2021-2024MY
K5 (DL3a)
w/Theta III 2.5L T-GDI

TECHNICAL SERVICE BULLETIN

ITM REPLACEMENT AND ECM
LOGIC IMPROVEMENT (CA2511)

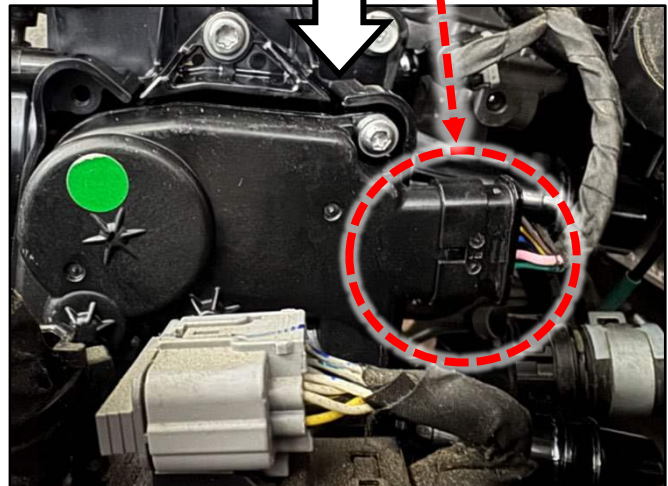
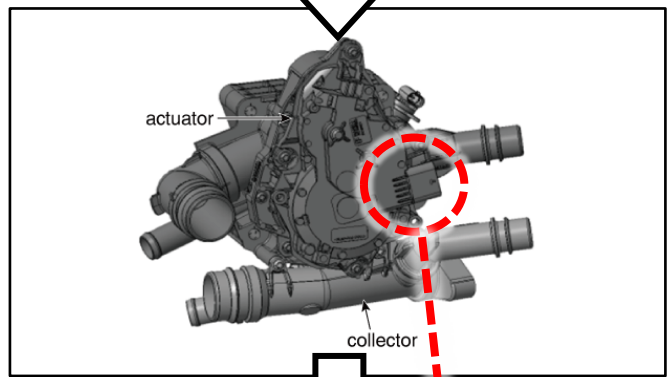
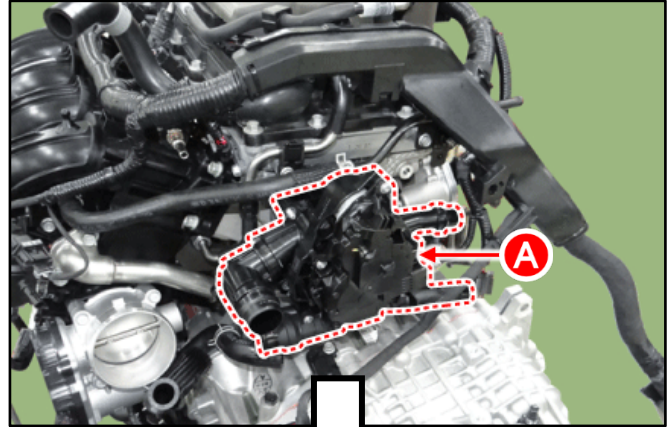
1. Replace the Integrated Thermal Management Module 'ITM' (A) by referring to "Engine Mechanical System → Cooling System → Integrated Thermal Management Module (ITM) → Repair procedures" in the applicable Shop Manual on KGIS.

DO NOT disassemble the actuator and collector. The new ITM is supplied as an assembly unit.

Tightening torque for bolts:
7.2 - 8.7 lb.ft (9.8 - 11.8 N.m)

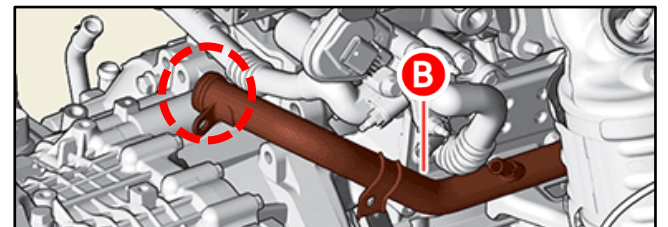
Note: The ITM connection orientation changes after replacing the new ITM part. The locking tab will face the engine.

Trying to make the connection on the new ITM in the same orientation as the original ITM may damage the connector pins/terminals.

3. Install a new inlet pipe (B) O-ring on the red circled area shown.
4. Proceed to upgrade the 'ECM' with Event 850 software in **Manual Mode** only, after ITM part replacement is completed by referring to the ROM ID table on page 4.
